# Access Compliance Report

### (Curb Ramps)

Intersection ID: 46910	Main Street: PENCE_RD	Cross Street: PARKERS_CROSSING_DR	Location: NW
ADA ID: 7BF3D7229FFA	Ramp Type: PerpDiag	Initial Pass/Fail: Fail	Overall Compliance: No
			Severity Score: 21.25

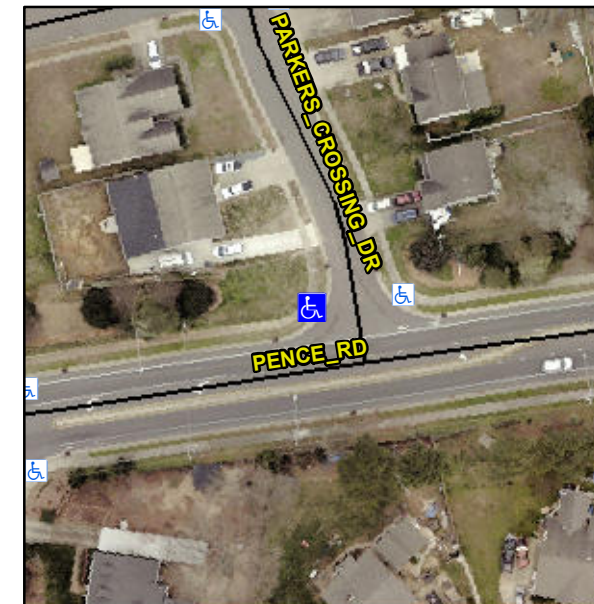
**Not Found, R304.5.1, R304.5.3**

Compliance	Description	Data	Compliance	Description	Data
N/A	Ramp Length (in)	47.0	Yes	Ramp Slope (%)	5.3
No	Ramp Width (in)	37.0	No	Ramp XSlope (%)	5.3
N/A	Flare Type LT	N/A	N/A	Flare Type RT	N/A
N/A	Flare Slope LT (%)	N/A	N/A	Flare Slope RT (%)	N/A
N/A	Flare Traversable LT?	N/A	N/A	Flare Traversable RT?	N/A
N/A	Landing Length (in)	N/A	N/A	DWS Provided?	N/A
N/A	Landing Width (in)	N/A	N/A	DWS Contrast?	N/A
N/A	Landing Slope (%)	N/A	N/A	DWS Length (in)	N/A
N/A	Landing X Slope (%)	N/A	N/A	DWS Full Width?	N/A
N/A	Landing Curb? (Y/N)	N/A	N/A	DWS Offset (in)	N/A
N/A	Shared Landing?	N/A			
N/A	Gutter Ponding?	N/A	N/A	Gutter Slope (%)	N/A
N/A	Gutter Lip Ht (in)	N/A	N/A	Gutter X Slope (%)	N/A
N/A	Painted X Walk1?	No	N/A	Painted X Walk2?	No
	X Walk 1 Direction	To S		X Walk 2 Direction	To E
N/A	X Walk 1 Width (in)	N/A	N/A	X Walk 2 Width (in)	N/A
	X Walk 1 Slope (%)	2.4		X Walk 2 Slope (%)	5.2
	X Walk 1 X Slope (%)	6.4		X Walk 2 X Slope (%)	1.8

**Remove & Replace Curb Ramp With Two New Directional Ramps or Equivalent.**
